RFQ CCC-039 Instructional Building #1 - ADDENDUM 1

1. Pre-Bid RFC-001 through 004 and RFC-006 through 011 with Answers

2. Changes to the Specifications

3. Changes to the Drawings

1 FIRE DEPARTMENT ACCESS PLAN
 CP0.00 SCALE: 1" = 40'

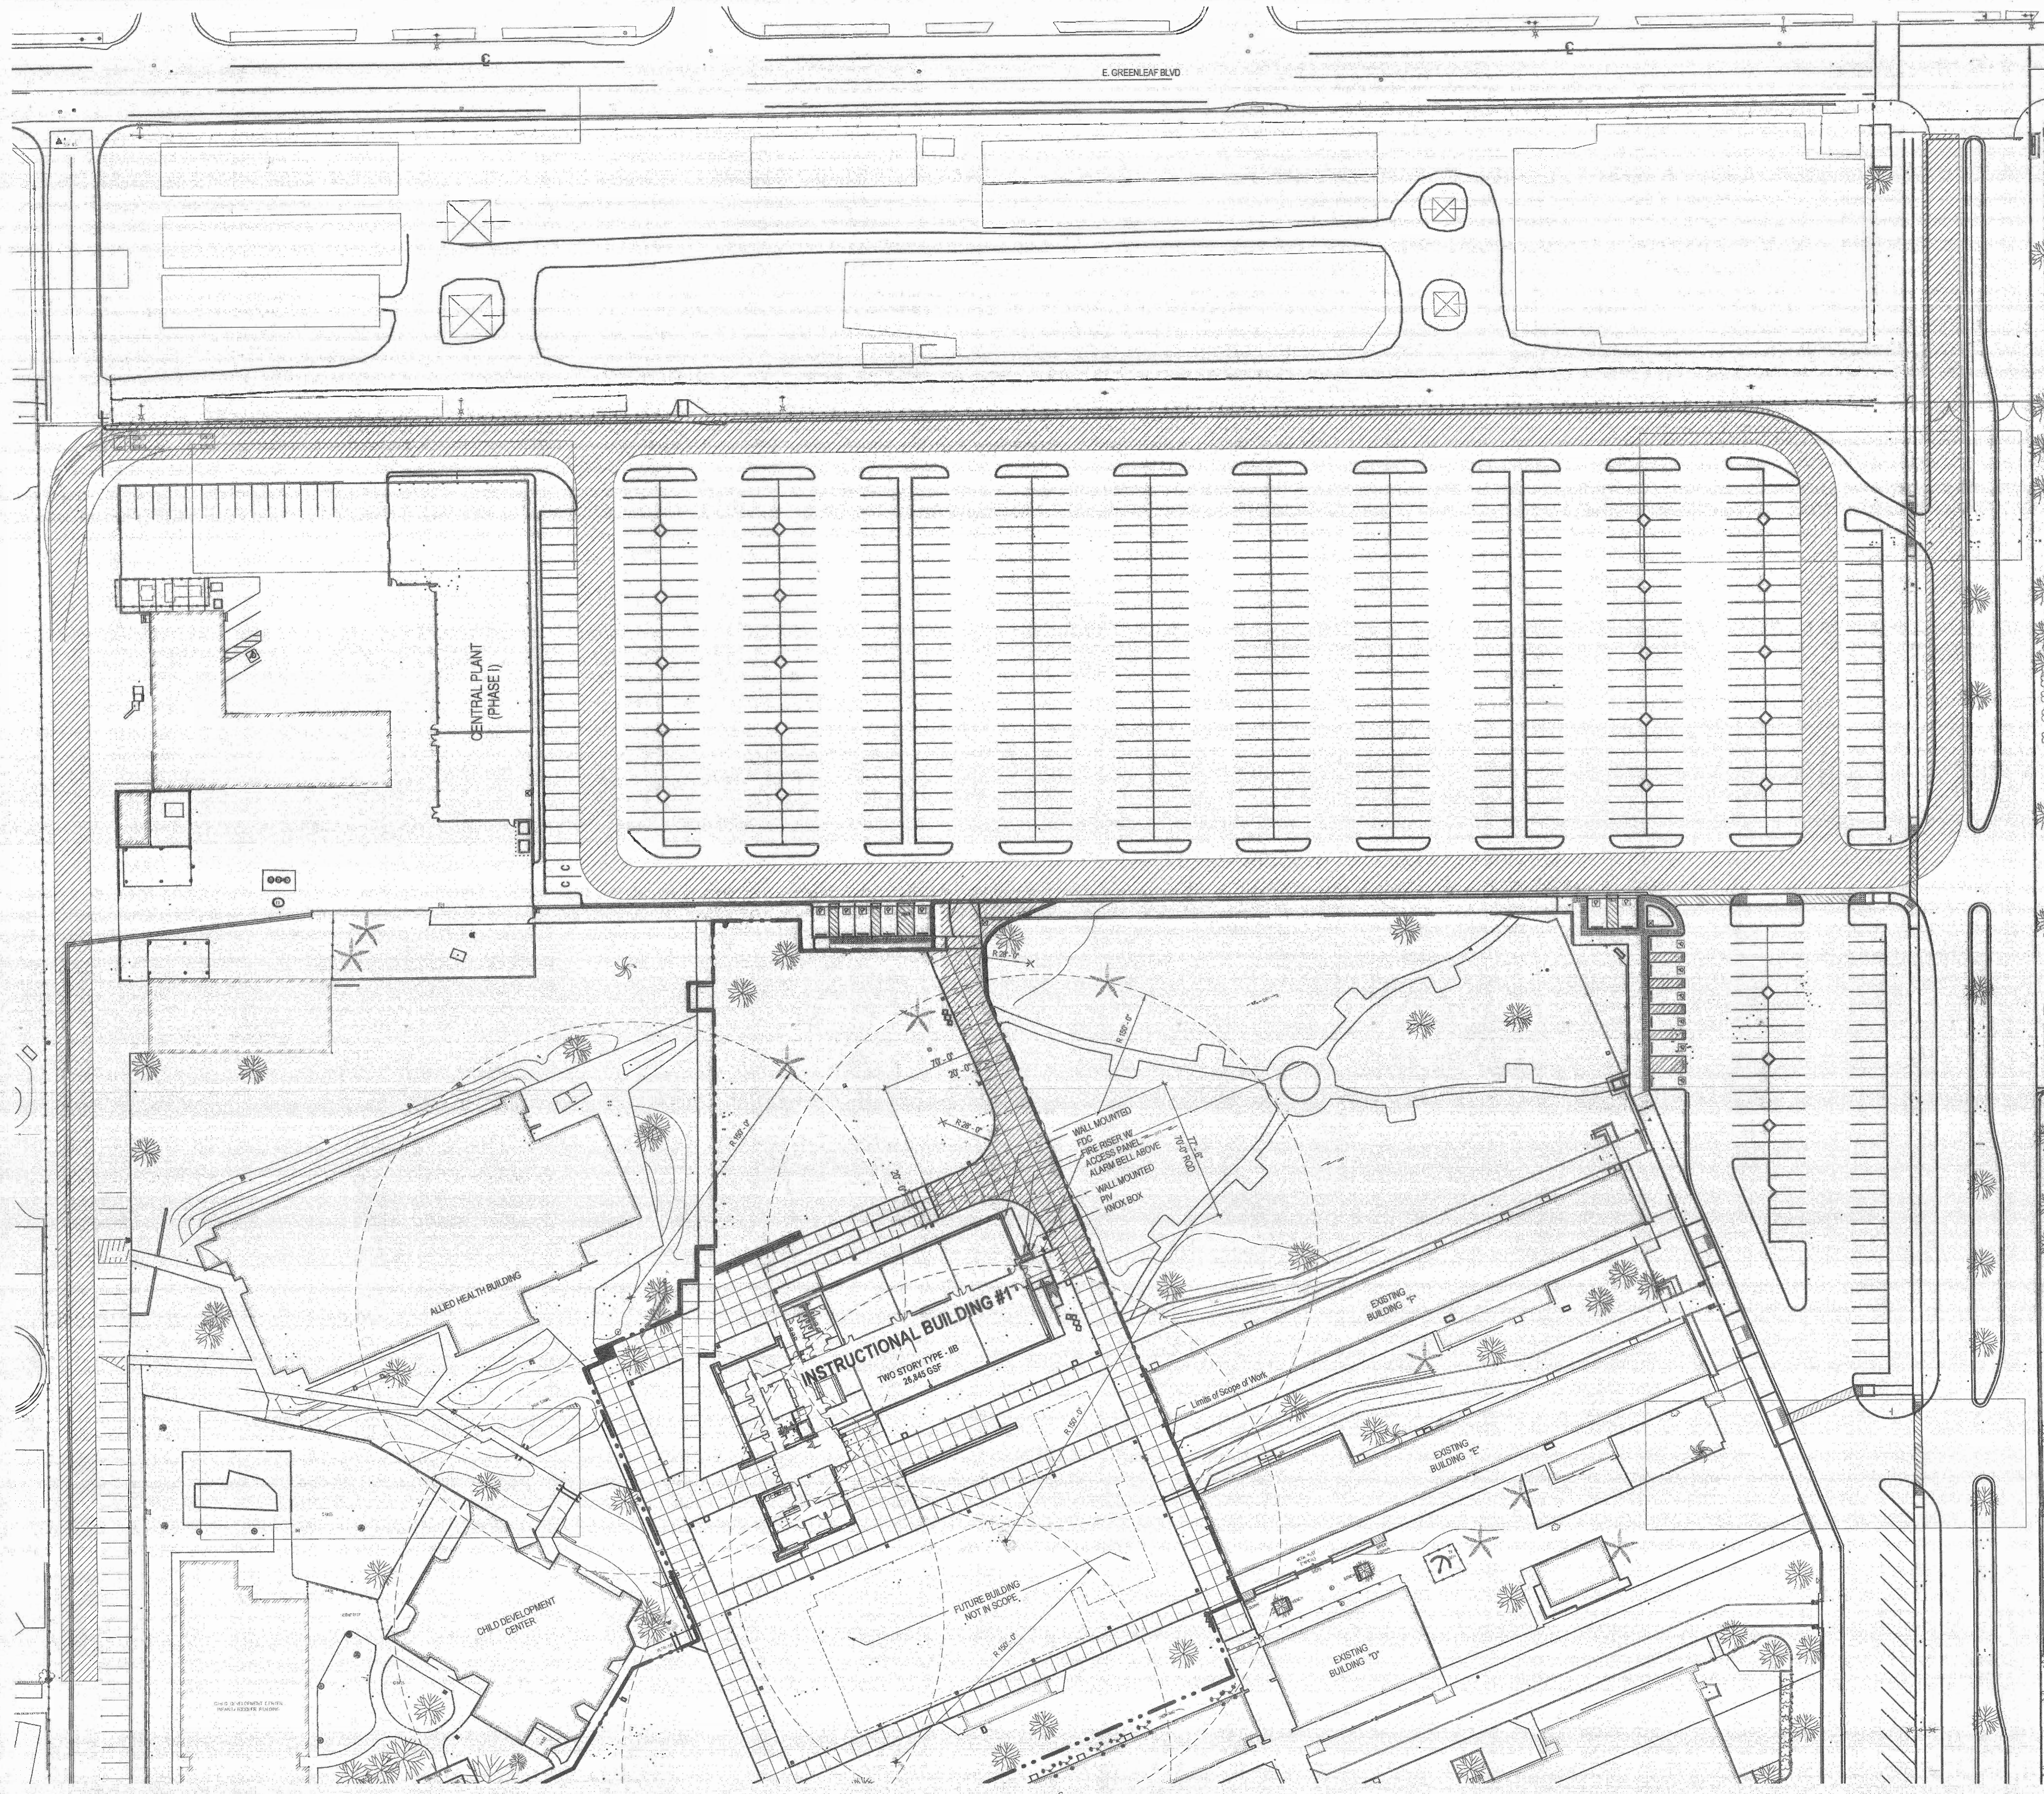
This RFI pertains to Fire Department Access Plan (CP0.00) and Demolition Site Plan (AD0.11).

Item 1. The comment under the description of Local Fire Authority Review says that "Permit Required for Installation". Please advise and clarify.

1. CP0.00: A permit from the local Fire Authority will be required to install the new fire hydrant and FDC (Item 3 and Item 11 on C5.01) located just east of the new building.
2. See attached plan of Building E for location of below grade pylons.

2 STR-01 SOLID SURFACE @ PLATFORM OVERHANG
SCALE: 3" = 1'-0"

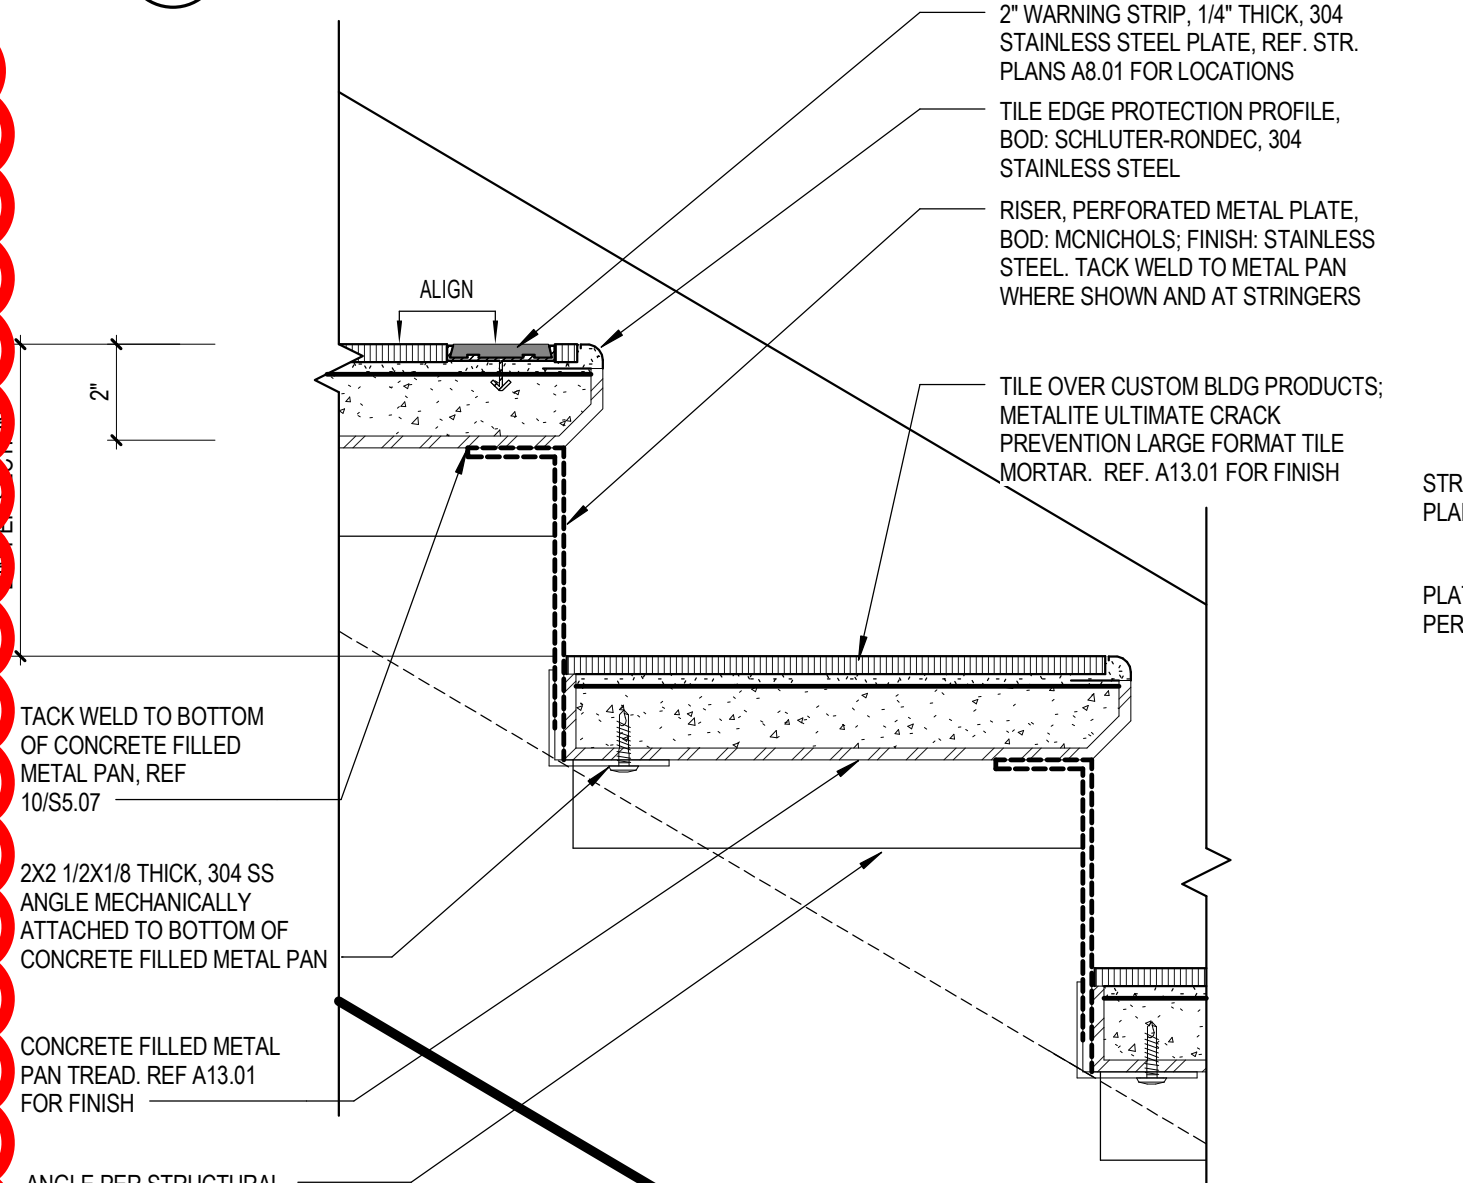
This RFI pertains to Stair Details (A8.07). The exact location of detail #2 STR-01 Solid Surface @ Platform Overhang is not clear. Please advise.

- The referenced item is the platform beneath Stair #1. The path to this detail is as follows:
 1/A1.01 > 1/A8.01 > A8.01 elevation 12 > 19/A8.07 > 2/A8.07

EXTERIOR WALL TYPES

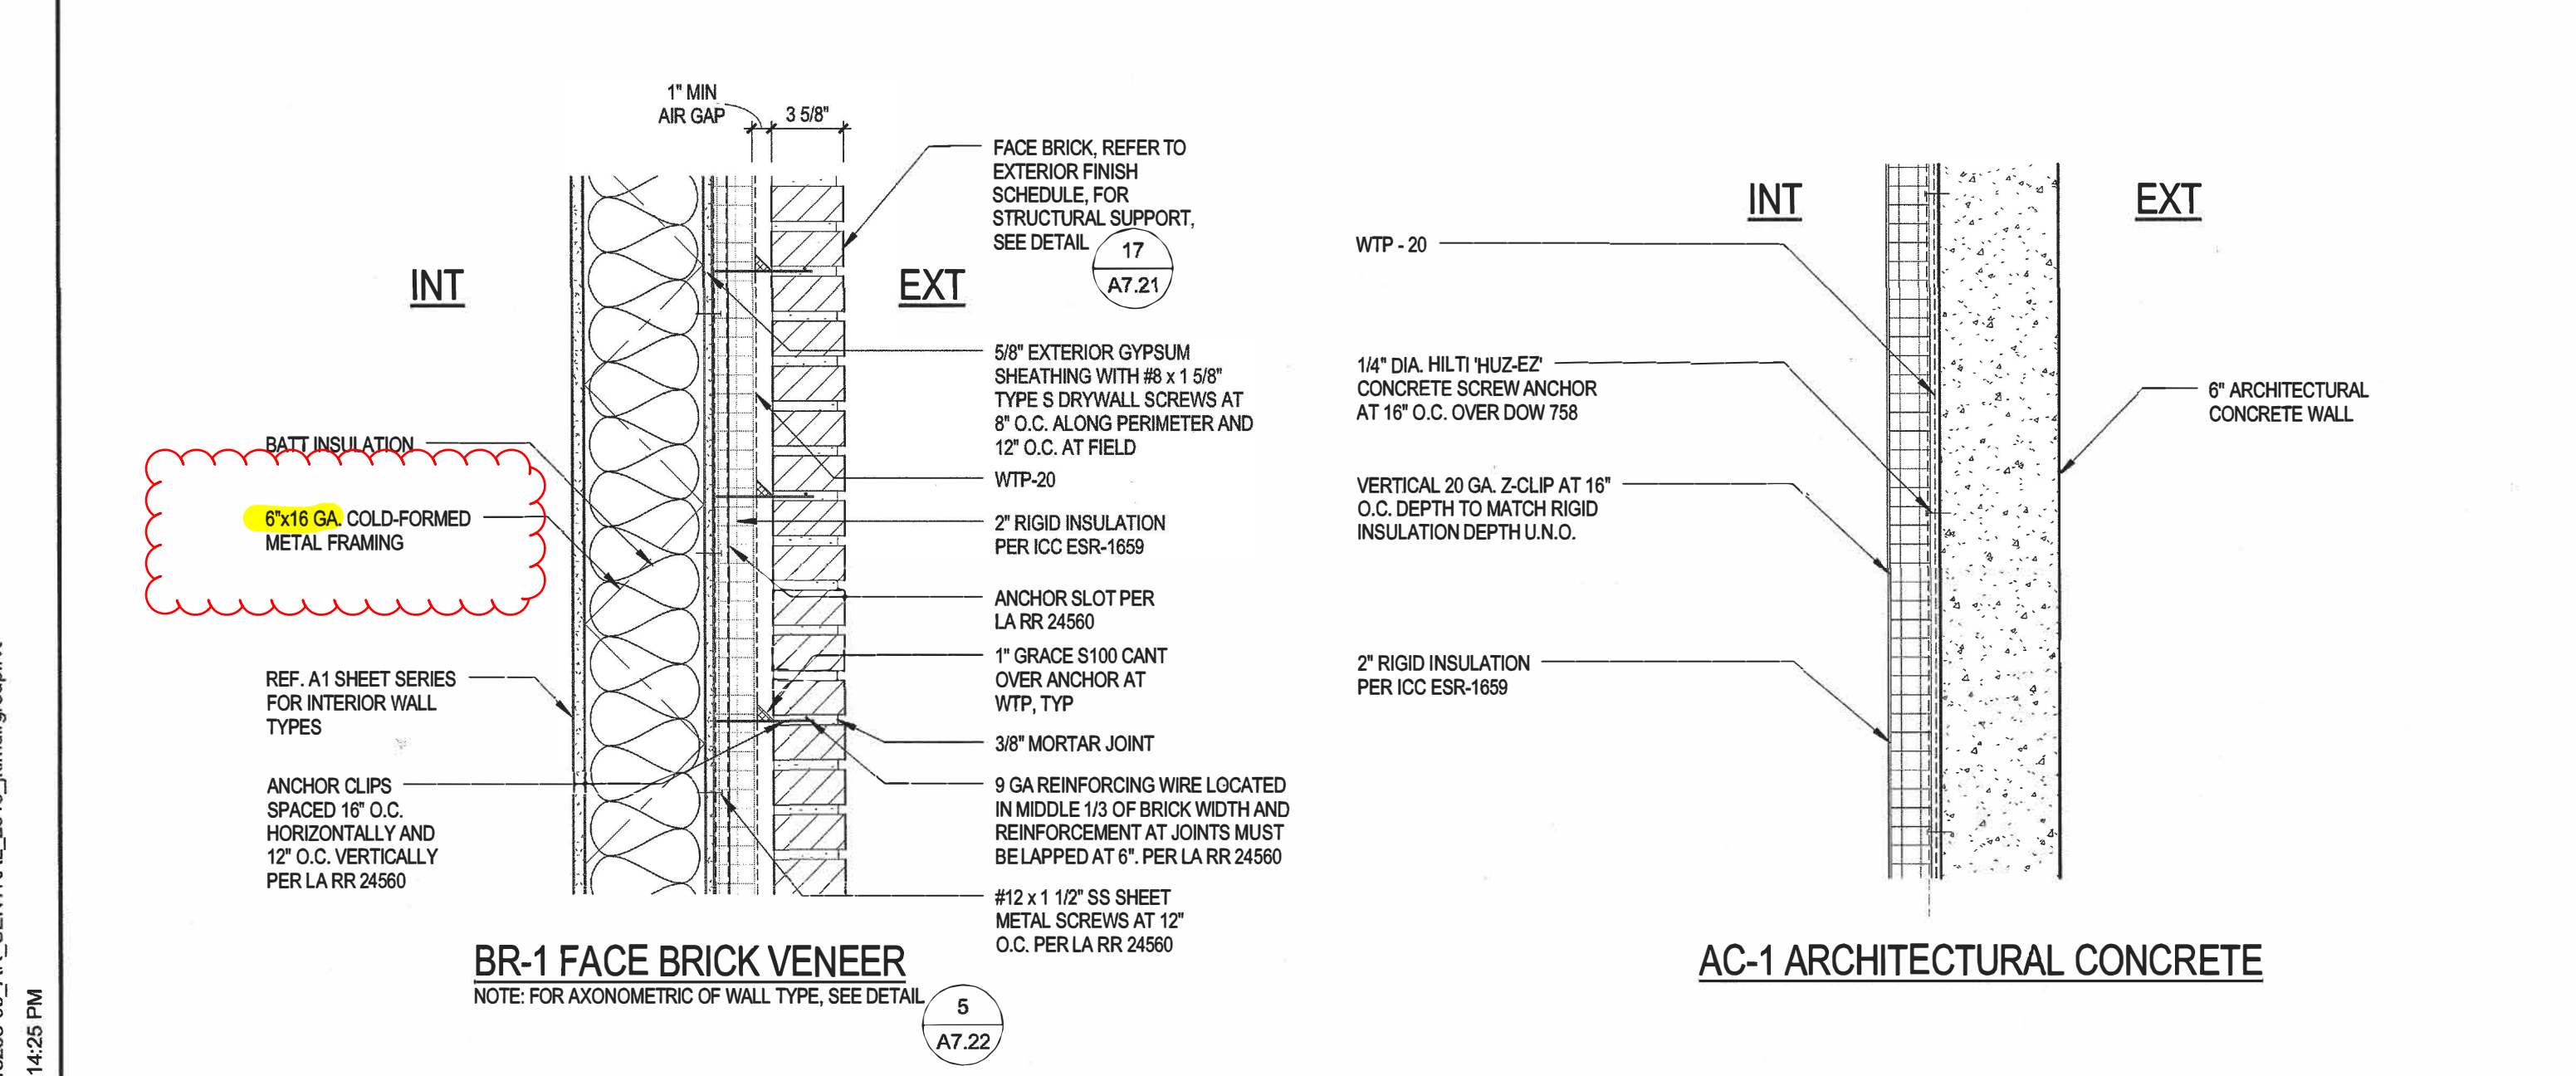
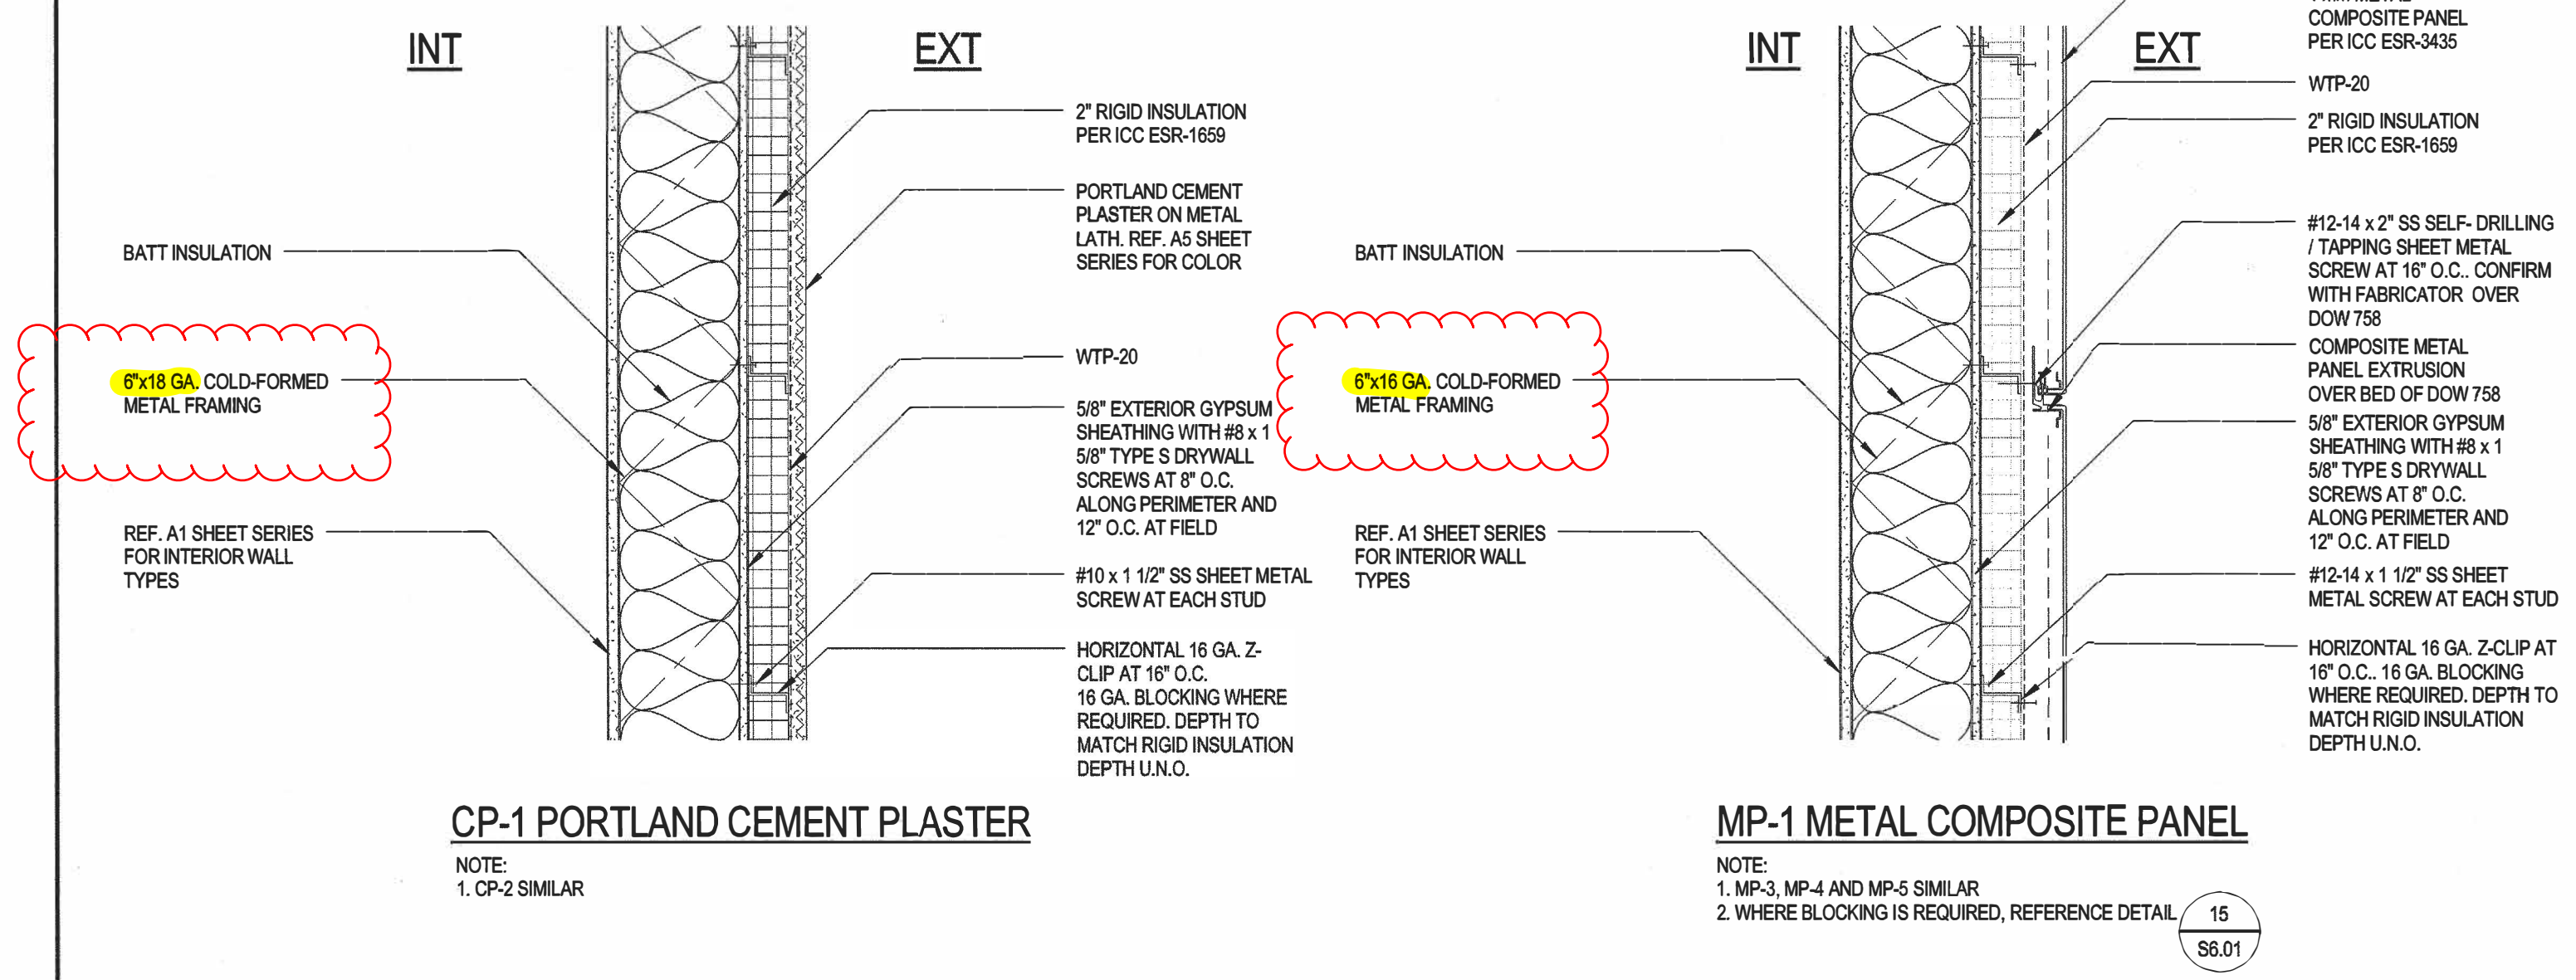
This RFI pertains to Wall Types plan(A9.01). The cold-formed metal framing of exterior walls are not clear (CP-1: 6"x18 GA / MP-1 & BR-1: 6"x16 GA). Please advise.
